TECHNICAL BULLETIN

No: LA-310-001
Issue: 1
Date: 10 Nov 2005

Fuel Filler Flap Latch Repair

LR3 (LA) ALL

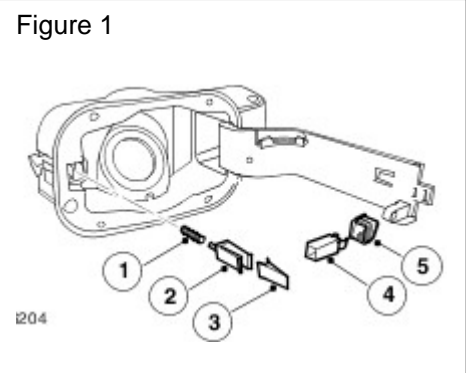
A customer may report a concern of difficulty in opening or closing the fuel filler flap.

Cause: Fuel filler flap release catch parts can break during use which may result in difficulty in the opening or closing of the flap.

Action: Component parts of the fuel filler flap release catch are now available as individual spare parts. Previously the entire fuel filler flap assembly had to be replaced to affect a latch repair. This Technical Bulletin announces availability of the release catch parts for repairs. Should a customer express concern regarding the above, only the appropriate part(s) should be used to repair the vehicle.

Description	SRO	Time (Hours)	Condition Code	Causal Part
Replace fuel filler flap release mechanism (illustration items 1,2,3)	19 55 16	0.10	01	Use part replaced from listing above
Replace fuel filler flap catch/seal (illustration items 4,5)	19 55 15	0.10

1. Open the fuel filler flap.
2. Renew the catch mechanism parts as necessary.
